May 2019
INT FL806-01/02
NHTSA #19V-066
Transport Canada #19-054
INTERIM RECALL BULLETIN
SECOND REVISED NOTICE

Subject: Freightliner Cascadia Steering Wheel Airbags

Models Affected: Specific Freightliner Cascadia vehicles manufactured August 3, 2017, through January 30, 2019.

Fig. 3, GNDP Floor Stud Location

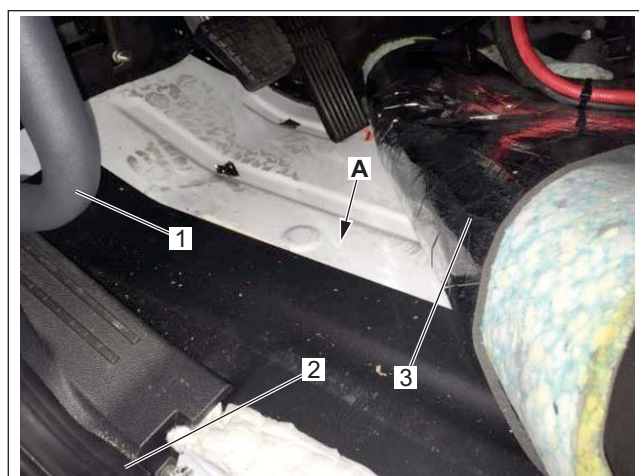
- Instructions for a damaged GNDP floor stud have been added in step 10.
 - The torque value for the GNDE pass through stud has been corrected.
 - The contact information for the airbag manufacturer has been edited in step 15.

- 10.1 Remove the driver's-side sill cover, the lower A-pillar cover, and the lower steering wheel cover. See [Fig. 3](#).
- 10.2 Roll back the driver's-side floor mat far enough to access the center floor area above the stud, where the bolt is installed.
- 10.3 Locate the mounded area on the floor, directly above the GNDP stud location.
- 10.4 Locate and mark a spot directly between the mound and the closest rivet. The center will be approximately 5/16 inch (7.9 mm) from the edge of the rivet. Verify the area below the floor is clear, and drill a 5/16 inch (7.9 mm) hole through the aluminum floor at the spot marked. See [Fig. 4](#).

- 10.5 Use sand paper or a disc to clean the paint from both sides of the floor skin around the hole.
- 10.6 Use a cutoff wheel or suitable tool to cut the damaged stud off flush with lower floor skin.

- 10.7 Using a 5/16 x 1.25 bolt, install the A/C line support Z bracket, and secure it with a washer and nut. Torque to 14 lbf·ft (19 N·m).
- 10.8 Install a 5/16 inch X 1.25 inch (7.9 mm X 31.75 mm) bolt using star washers on each side of the floor skin. Then install the A/C line Z bracket, when used, and secure it with a nut. Torque the nut to 14 lbf·ft (19 N·m).

- 10.9 Install the GNDP ground cable on the remaining bolt threads, and secure with a second nut. Torque the nut to 14 lbf·ft (19 N·m).
- 10.10 Position the driver's-side floor mat in the vehicle and install the driver's side lower steering cover, the lower A-pillar cover, and the sill cover.
